Electrical Cabling Material Issues

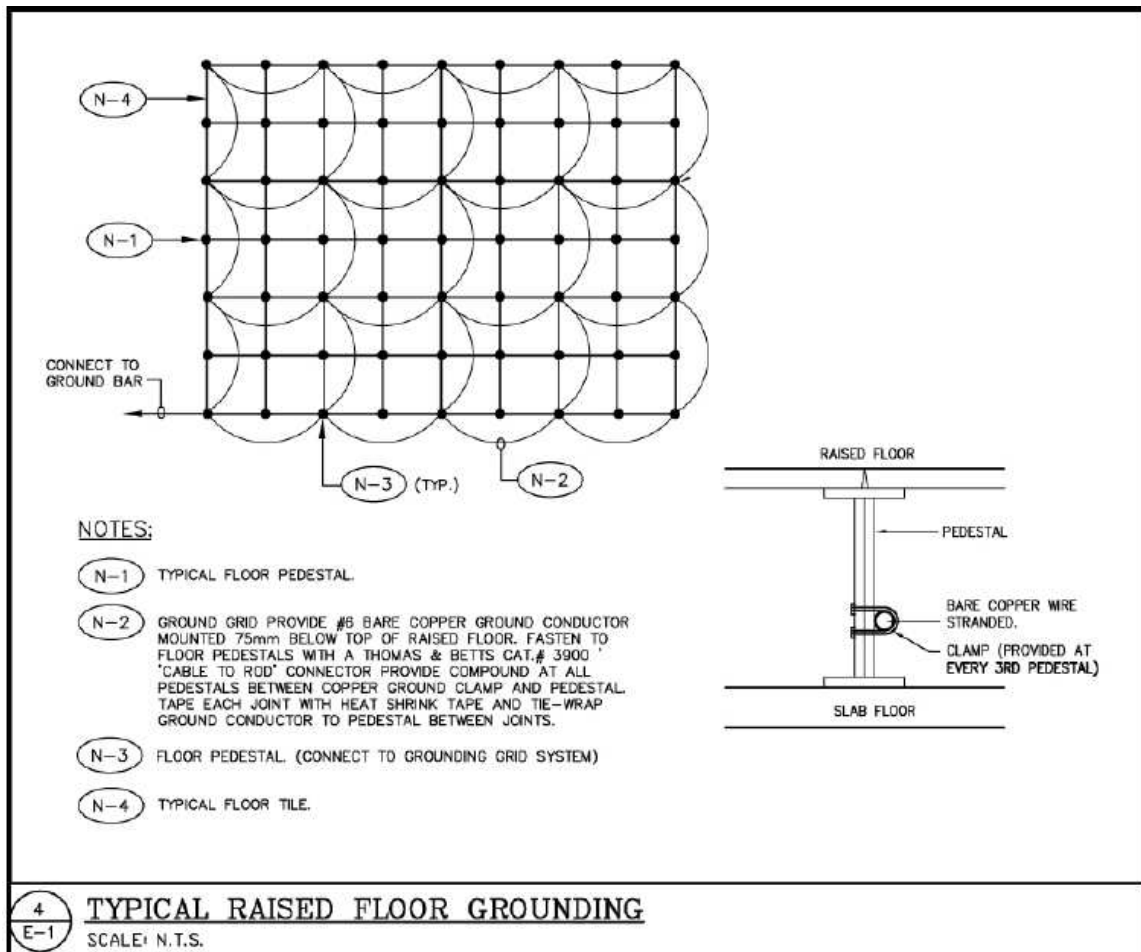
NEMA 5-15R "straight-blade" receptacles and power bars have been installed under the floor in the 510 Main St. computer rooms. This is not allowed by the Canadian Electrical Code (Rule 12-

020). Where the use of these types of receptacles is unavoidable, they should be installed above the raised floor or in a recessed floor box to satisfy the CEC.
